# Technical Service Bulletin

SUBJECT: <b>INCORRECT DTC P0317 STORED ON TCM (6B31)</b>			No: <b>TSB-17-23-001</b>
			DATE: <b>February, 2017</b>
			MODEL: <b>2017 Outlander</b>
CIRCULATE TO:	<input type="checkbox"/> GENERAL MANAGER	<input checked="" type="checkbox"/> PARTS MANAGER	<input checked="" type="checkbox"/> TECHNICIAN
<input checked="" type="checkbox"/> SERVICE ADVISOR	<input checked="" type="checkbox"/> SERVICE MANAGER	<input checked="" type="checkbox"/> WARRANTY PROCESSOR	<input type="checkbox"/> SALES MANAGER

## TCM REPROGRAMMING CHART

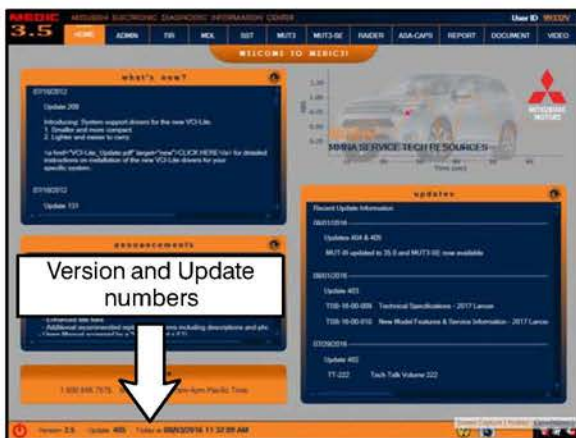
Due to improper programming of the Transaxle Control Module (TCM), DTC P0317 may be stored incorrectly in the TCM. This may happen when CAN data communication fails between the Electric Parking Brake (EPB) ECU and the TCM, such as when the EPB connector is disconnected. The correct DTC that should be recorded in this case is U0317, CAN time-out error (EPB).

This TSB instructs dealers to reprogram the TCM with updated software to correct the issue.

Model	ECU Part Number	Data No.	Software Part Number	
			Previous	New
2017 Outlander (6B31) (GF0W, W6AJA)	8631B552	8631B801	8631B552 0A	8631B552 0B
